ADDENDUM

Addendum No.: 3 Page: 1 of 5 Date: December 3, 2019

# Tender: 2019-31-T Bathroom and Kitchenette Renovations

# WORKPLACENL WASHROOMS 148 FOREST ROAD, ST. JOHN'S, NL, A1A 1E6

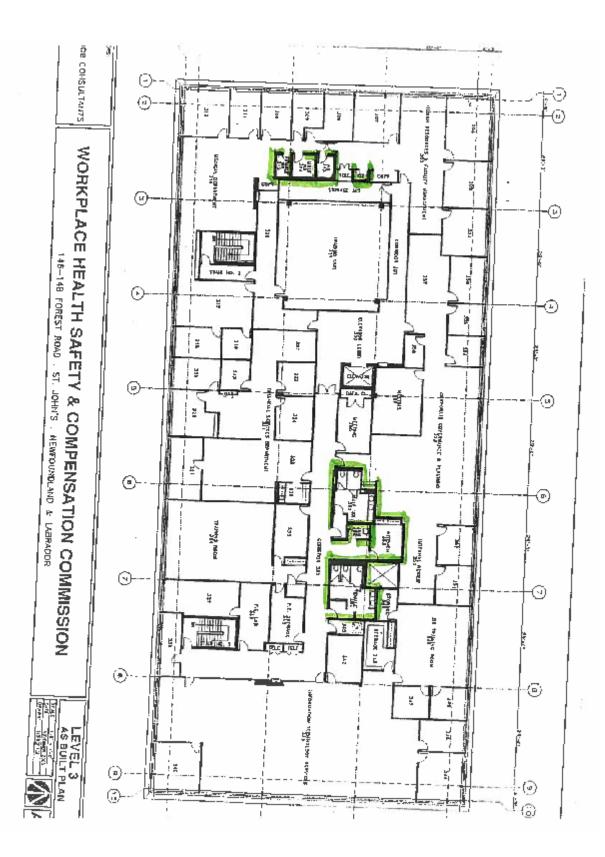
23. The wall tile detail on drawing A430 shows 8" however the reflected ceiling plan shows 9"? What is the correct height of the wall tile?

**Response:** Wall tiles must extend to the ceiling grid in each room.

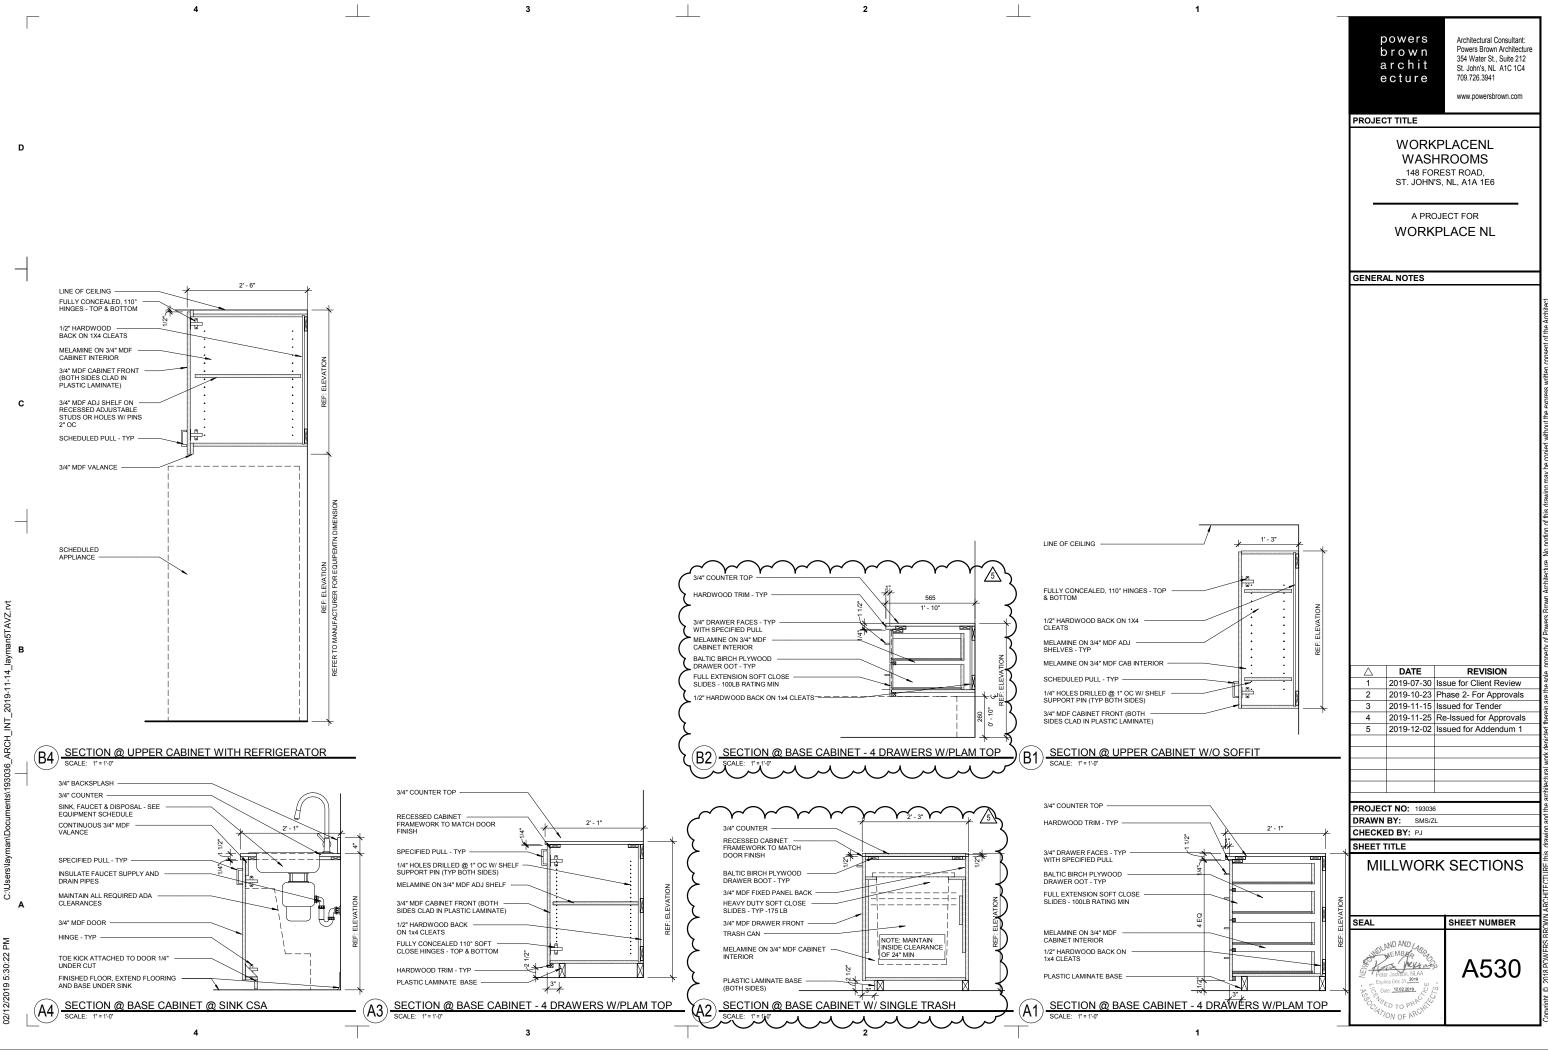
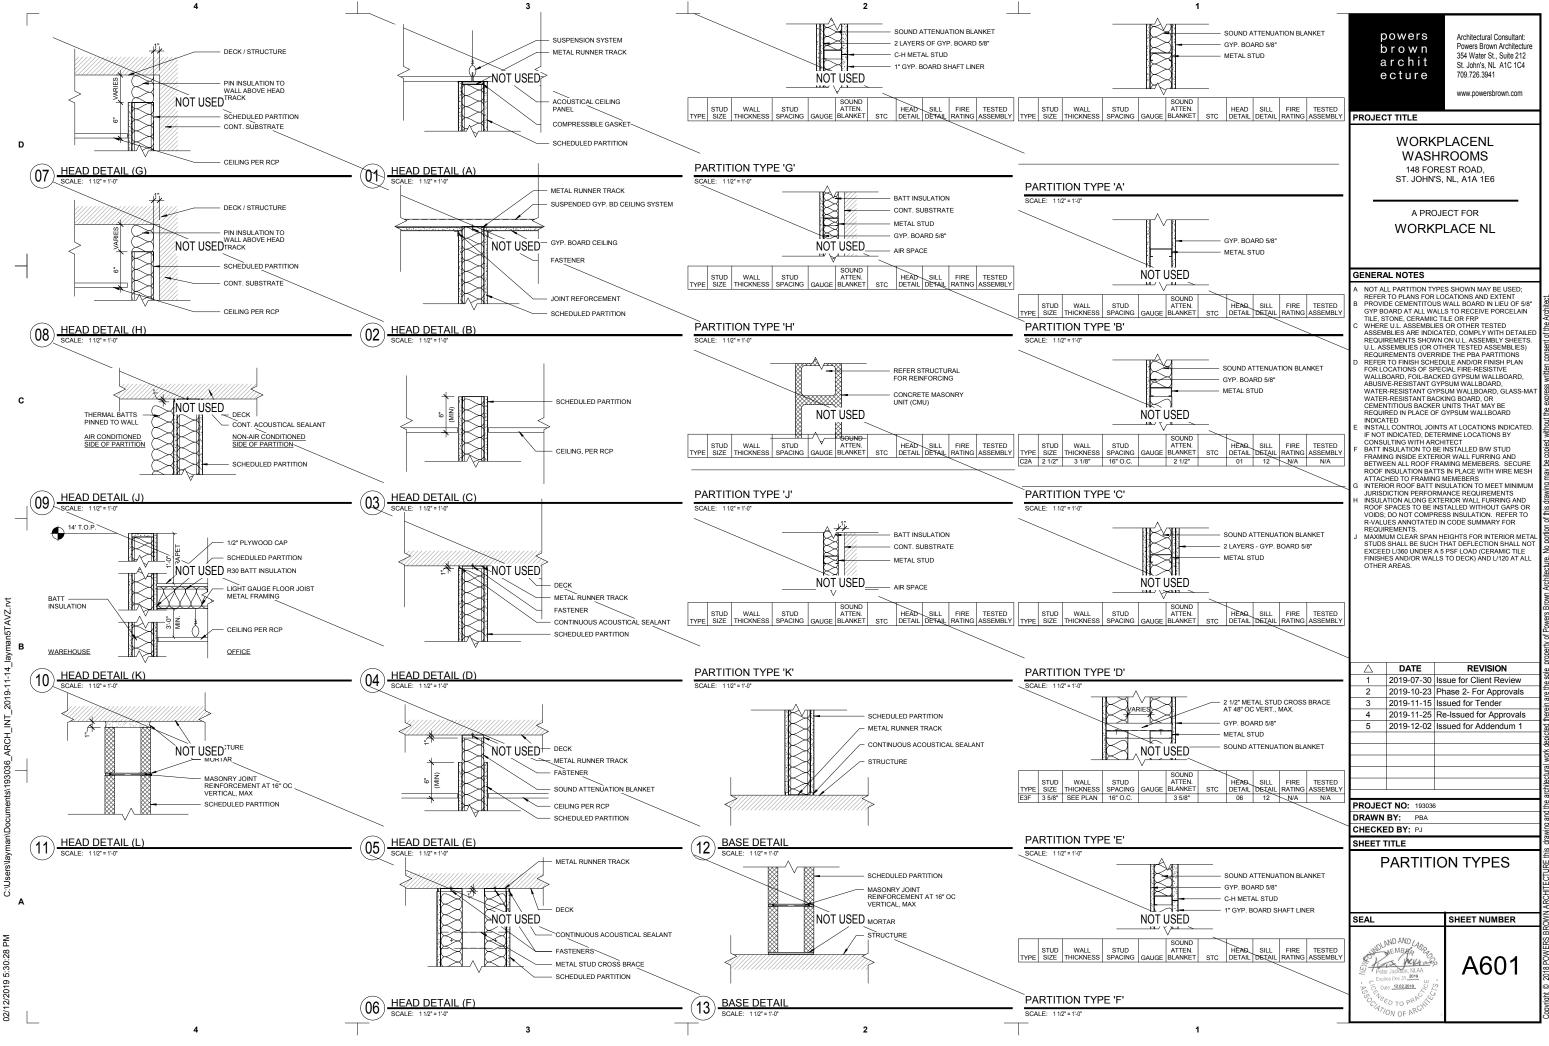
12. Room finish schedule notes washroom ceilings are gypsum, however reflective ceiling plans show T-bar.

**Response:** Gypsum board with pot lights has been removed from the drawings. C2 on A604 drawing indicates acoustic tile ceiling to be used.
